Job Number: 230020
Date: 2 November 2023

GRC Hydro
Level 20, 66 Goulburn Street
Sydney NSW 2000

Re: Stage 2 Review - Flood Advice for a State Significant Concept Proposal – 39-43 Hassall Street, Parramatta, NSW, 2150 – Build-to-Rent Residential Development

Figure 1: 1% AEP Flood Level Difference under 15% Bridge Blockage + Climate Change Scenario – Proposed Development minus Existing Case

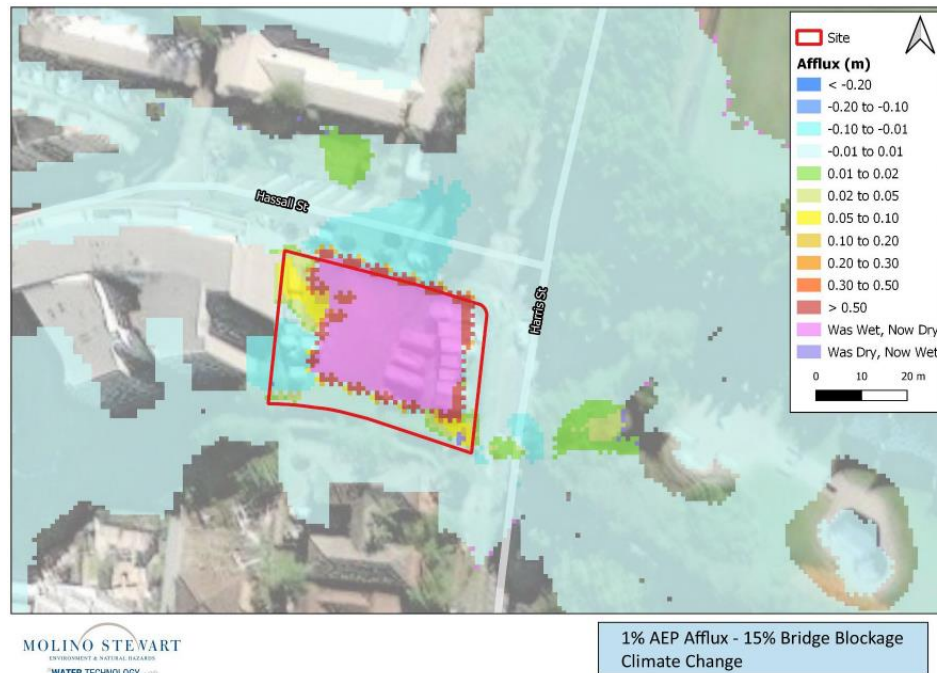
Lyall & Associates provide a figure documenting the flood impact of the proposed development on flood behaviour under potential future climate change conditions in a 1% AEP event. In other words, a figure that identifies the flood level difference between:

- The 1% AEP event with potential future climate change conditions – post-development scenario; and
- The 1% AEP event with potential future climate change conditions – existing scenario.

L&A and MS provided this figure in their 20 June 2023 response (see Figure 1 below).

Figure 2: MS map indicating potential points of floodwater ingress (20 June 2023)

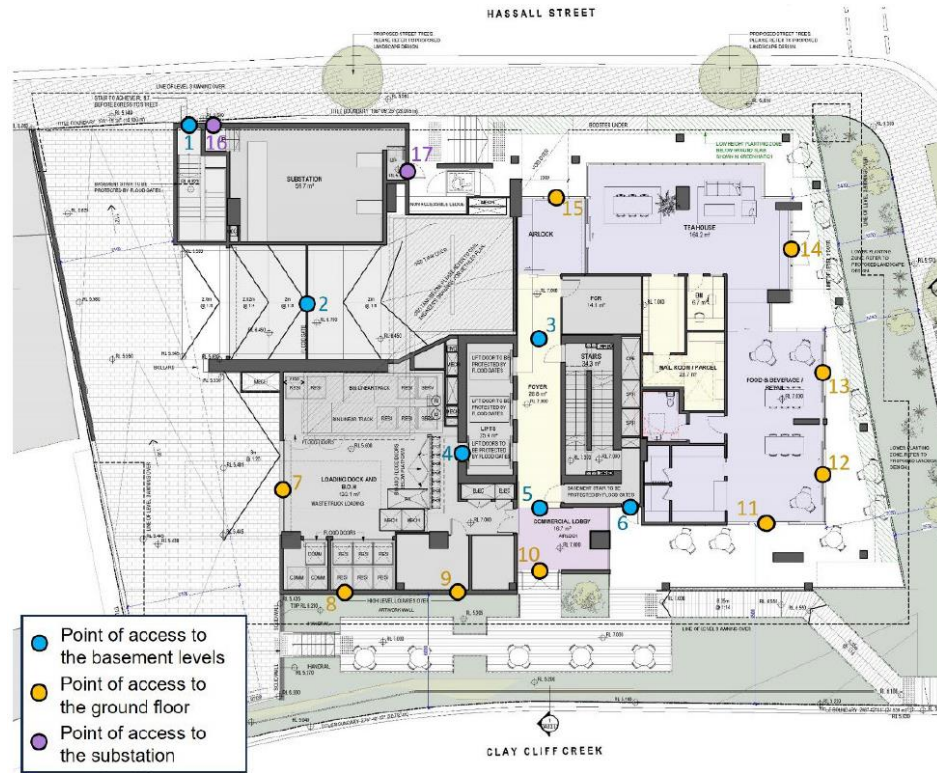
Molino Stewart confirm that there are no additional egress points on the ground floor than those identified in Figure 15 in GRC's Stage 1 Review.

The Flood Risk Assessment mentions that protection is offered up to the PMF level. GRC request that Molino Stewart confirm the level (in mAHD) of protection offered by the flood gates and doors identified in Figure 15 and Table 1 in GRC's Stage 1 Review.

MS's 20 June 2023 response noted that the ground floor layout had been amended since the completion of the Stage 1 review. MS collated a map of all of the updated ground floor egress points (Figure 2 below).

MS provided the below table identifying the newly updated ingress points, the level of protection offered at each point and GRC's assessment of whether adequate flood protection is afforded as per the DCP.

Figure 4: Flood Hazard (City of Parramatta issued Flooding Information for the site)

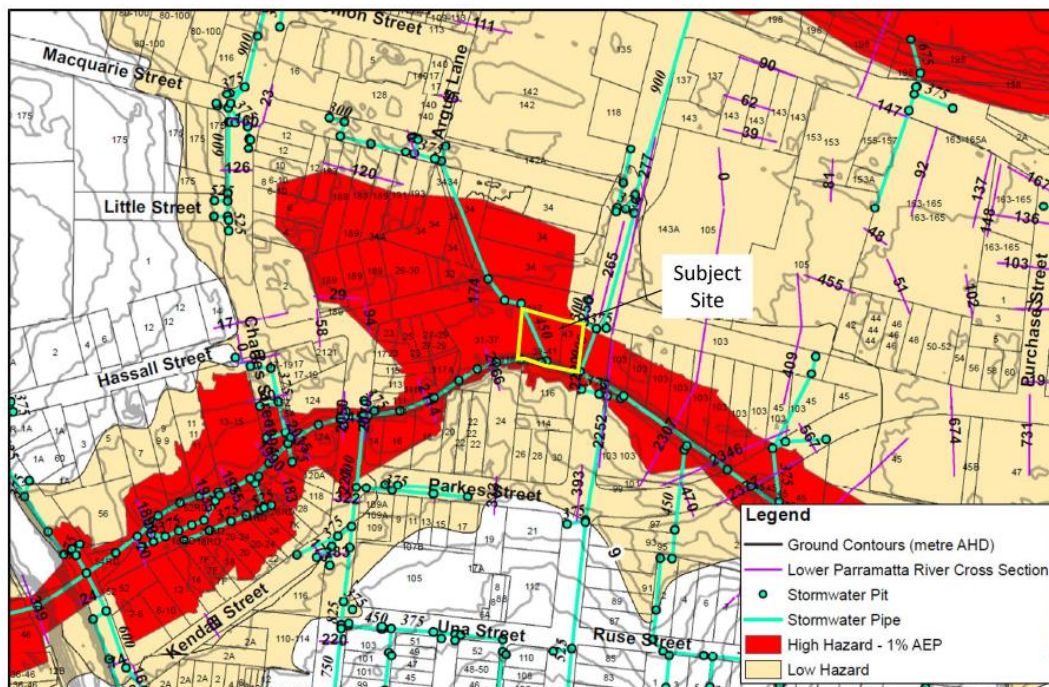
The flood information issued by the City of Parramatta identifies the site as being high hazard (Figure 4).

The Applicant asserts in their initial Flood Risk Assessment (13 January 2023) that in their “TUFLOW model (2022), the 1% AEP inundates parts of the site with flood waters with hydraulic hazard up to H3 (medium hazard) (Figure 4). The maximum hydraulic hazard on site would also be H3 if the creek floodwaters were to surcharge the channel in the 1% AEP event. Therefore, the site would be in the Medium Flood Risk Precinct using the precinct definitions in (Table 4 below).”

Figure 8 – Proposed Development Footprint at Ground Level (Rothelowman, DA01.06, 05/12/2022)

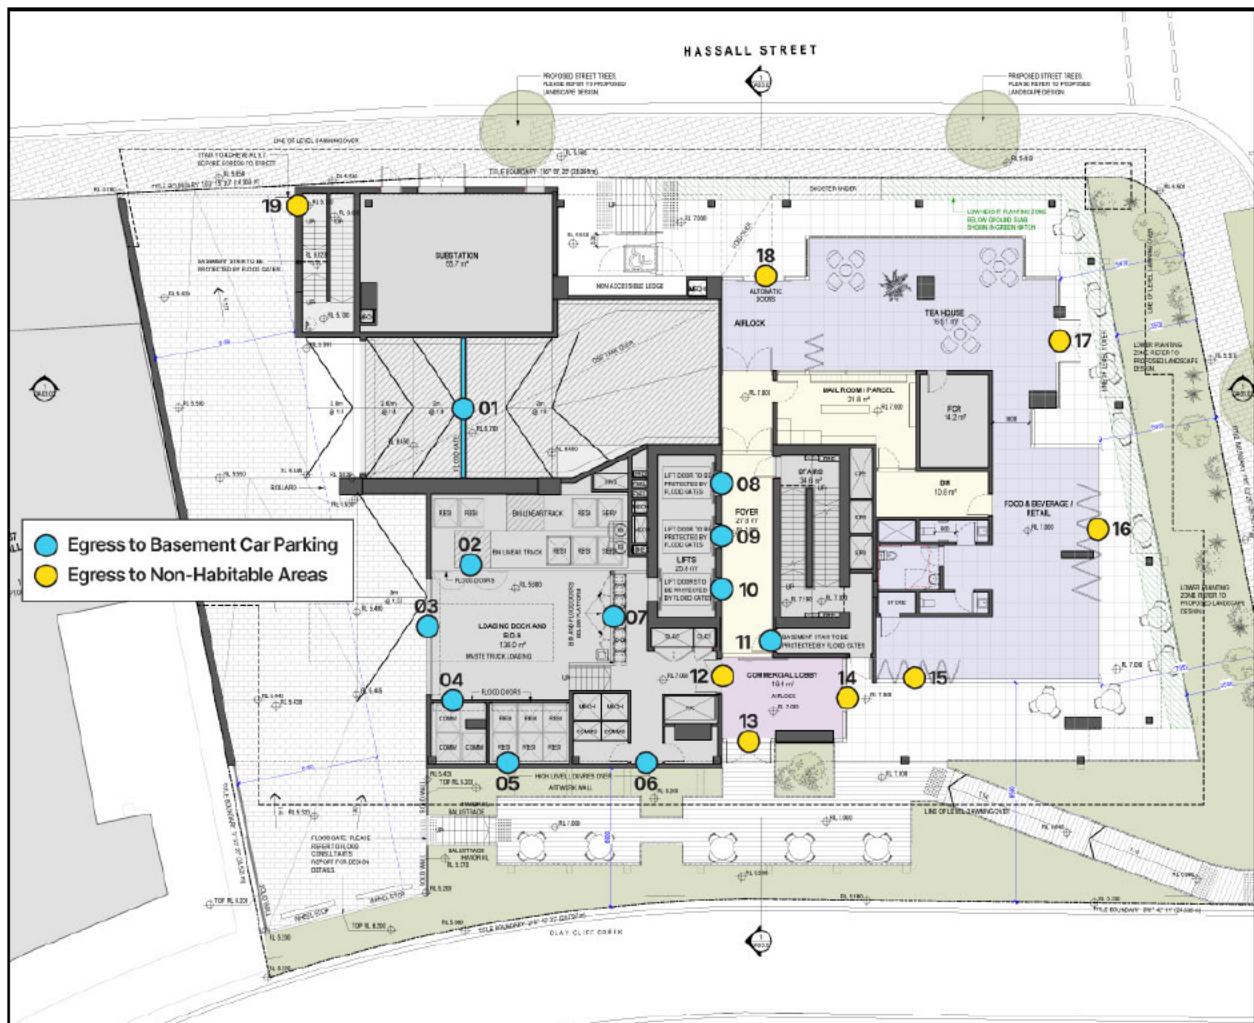
Based on the documentation regarding the proposed development that GRC has reviewed, these model changes appear reflective of the proposed post-development scenario.

This proposed development footprint is documented below in Figure 8 with annotations added by GRC to identify entrances and flood gates (as identified in Rothelowman’s ground floor plan (DA01.06, 05/12/2022) for the proposed development).

Figure 10 – Flood Hazard Categories – 1% AEP Post-Development Conditions (Lyll & Associates, 2022)

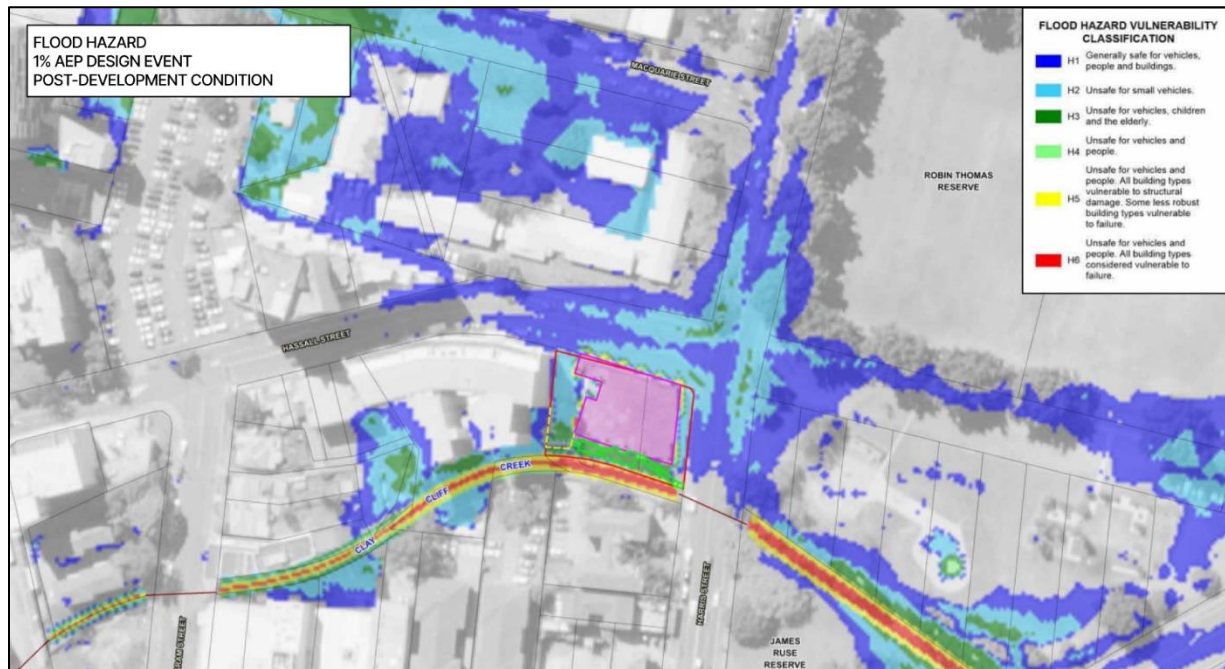
Figure 10 identifies the post-development hydraulic hazard categories in a 1% AEP event. There is some increase in hazard in the southern border and in the south-western corner where the hazard category has increased from H1 and H2 in the existing case, to H3 and a tiny pocket of H4 in the post-development case.

This area is not proposed to be a highly trafficked area. It is proposed that this area will include a paved area for car parking and a raised outdoor deck for seating at an elevation on 7 mAHD in a location where the 1% AEP flood level (as modelled by Lyll & Associates) is predicted to be in the order of 5.8 mAHD.

Figure 14 – Flood Level Impact – 1% AEP Event with Potential Impact of Climate Change (Lyall & Associates, 2022)

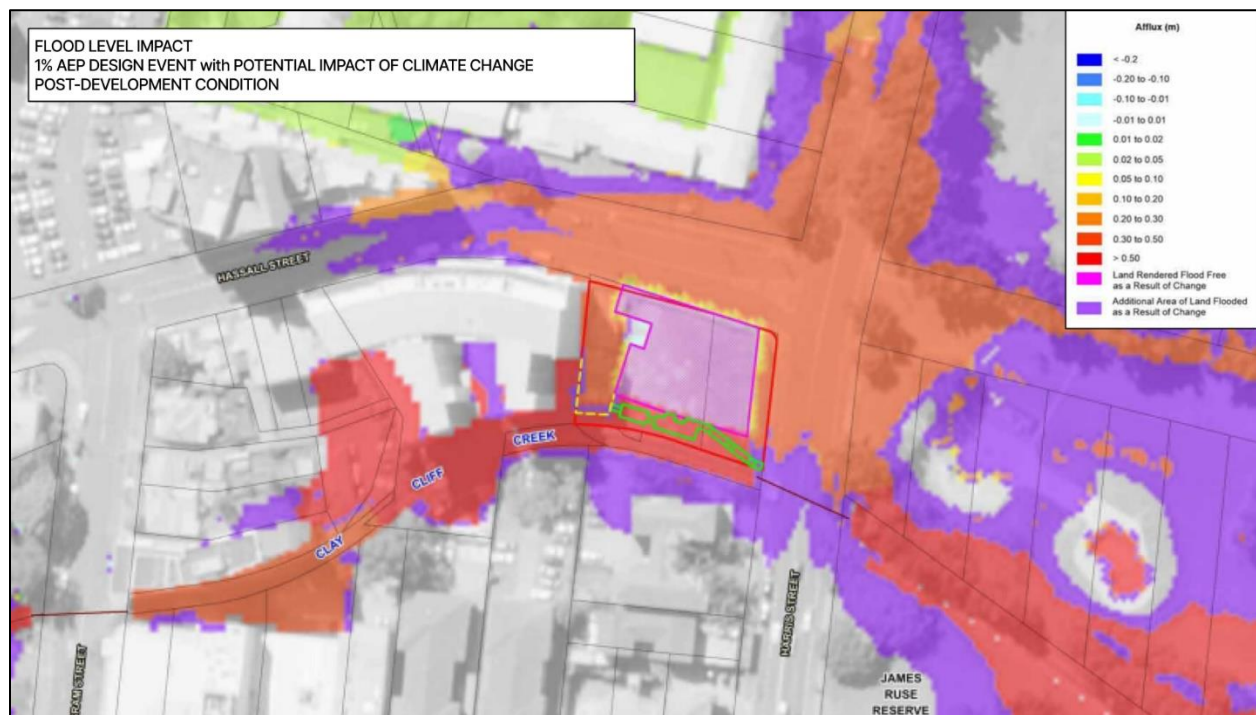
Figure 14 documents the potential flood level impact when incorporating this potential climate change impact.

In this scenario, impacts on and immediately adjacent to the site range from as little as 0.1 m to potentially greater than 0.5 m on the southern border where the site meets Clay Cliff Creek.

- Lyall & Associates provide additional information – in addition to Section 5.4.2 of the Flooding Investigation – as to why they believe the potential climate change conditions adopted for this modelling, including the stated tailwater increase, would be representative of the potential climate change impact in this catchment;

- Lyall & Associates provide a figure documenting the flood impact of the proposed development on flood behaviour under potential future climate change conditions in a 1% AEP event. In other words, a figure that identifies the flood level difference between:

Figure 15 – Flood Egress Points, Floor Levels and Usage at Ground Level (Rothelwman, DA01.06, 05/12/2022)

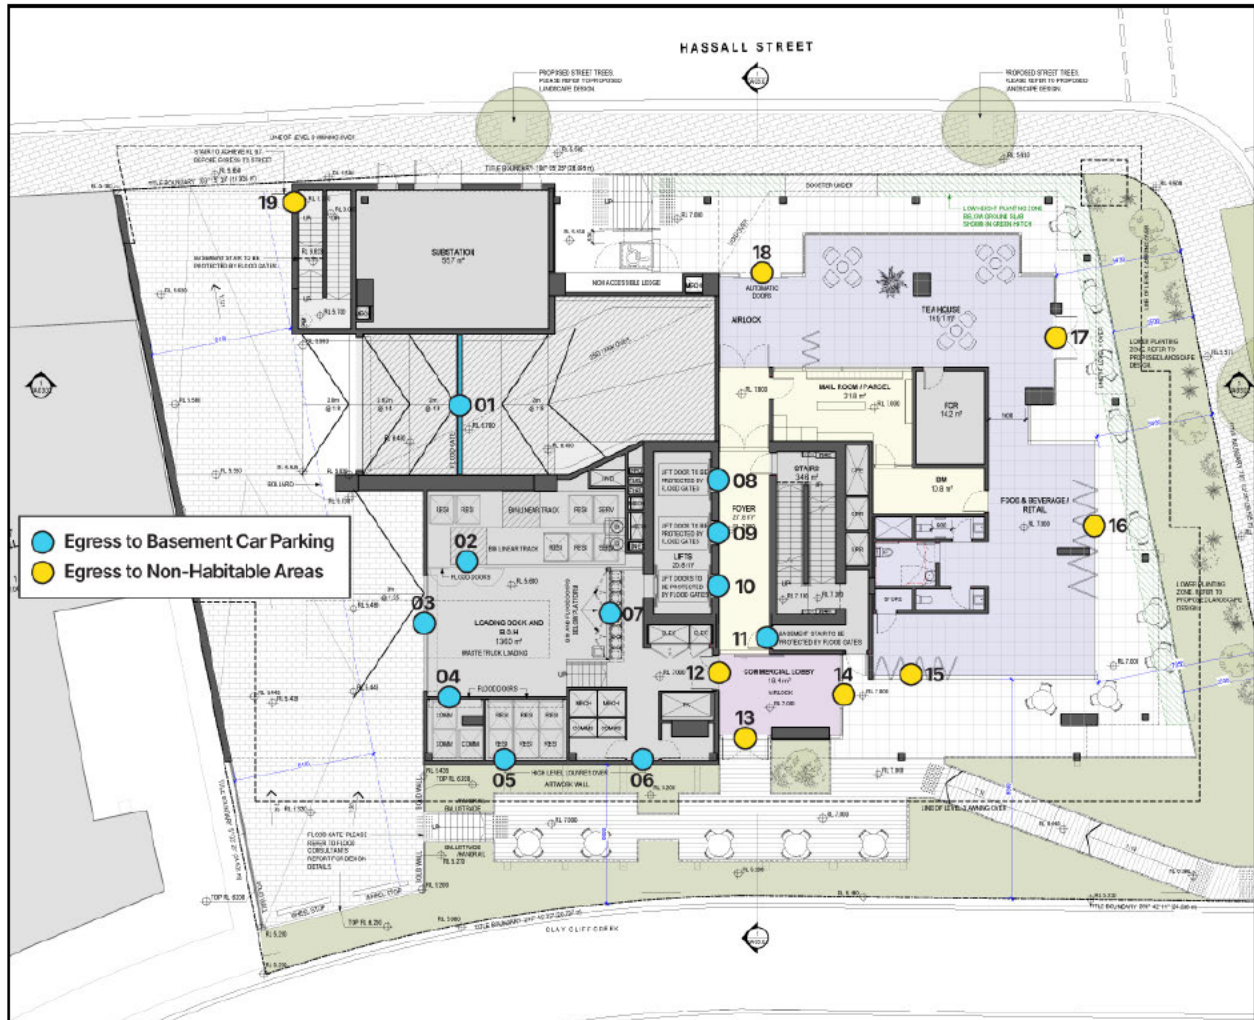
In order to verify this, GRC has assessed the FPLs against the egress points identified for the proposed development's ground floor (Figure 15 below).

The elevation at which each of these points is flood protected has been outlined in Table 1. The appropriate Flood Planning Levels – as identified on page 47 of Molino Stewart's Flood Risk Assessment – have been identified at each location for comparison.

- The 1% AEP event with potential future climate change conditions – post-development scenario; and
- The 1% AEP event with potential future climate change conditions – existing scenario.
- Lyall & Associates provide an assessment of the impact of proposed works given assumed 50% blockage of Harris Street bridge only;
- Molino Stewart confirm that there are no additional egress points on the ground floor than those identified in Figure 15 above; and
- The Flood Risk Assessment mentions that protection is offered up to the PMF level. GRC request that Molino Stewart confirm the level (in mAHD) of protection offered by the flood gates and doors identified in Figure 15 and Table 1 above.
